Date: User:	₹hursday, 12/13/2007 11:14:57 AM Kim Johnston	Process Sheet	
Customer Job Number	: CU-DAR001 Dart Helicopters Services : 36284		: VALVE ASSEMBLY (1/2")
Estimate Num P.O. Number This Issue Prsht Rev.	nber : 10727	Drawing Number	: D200108 : D2001 REV C : N/A
First Issue Previous Run Written By	: N/A Type : PURCHASED PAR	,,,,,,,,,,,,,,,,,,,,,,,,,,,,,,,,,,,,,,,	: C : NA : 12/19/2007
Checked & Ap Comment	pproved By :	RF	
Additional Pro	oduct

村村		DRAWN BY	DART AEROSPACE LTD HAWKESBURY, ONTARIO, CANADA				
CHECK	(ED)	APPROVED	DRAWING NO.	REV. C			
	-#-	#	D2001 SHEET	1 OF 1			
DATE			TITLE	SCALE			
04.0	7.06		VALVE ASSEMBLY	NTS			
		90.04.02	NEW ISSUE				
Α		92.05.12	-043 ADDED				
В		96.04.10	DART P/N CHG,041-6,042-12,ADD	-16			
С		04,07.06	ADD D2001-4

Subject: RE: D2001

SPECIFICATION CONTROL DRAWING

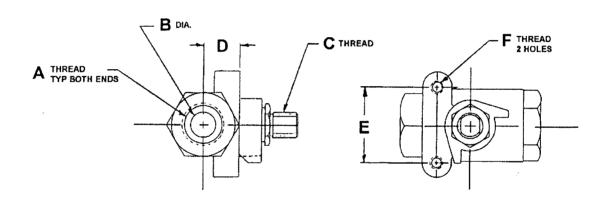
QC reported that the orientation of the left hexagonal fitting press fitted into the valve housing is inconsistent. Results, when trying to assemble the valve on the heater, there is some interference. They are asking if the parts would be acceptable if machined down as indicated per the provided sketches.

I don't see a problem with that. Do you?

David and I found no problem with this modification manufacture need to do, but we suggest this modification need to reflect in the drawing as an option since this is inconsistent problem.
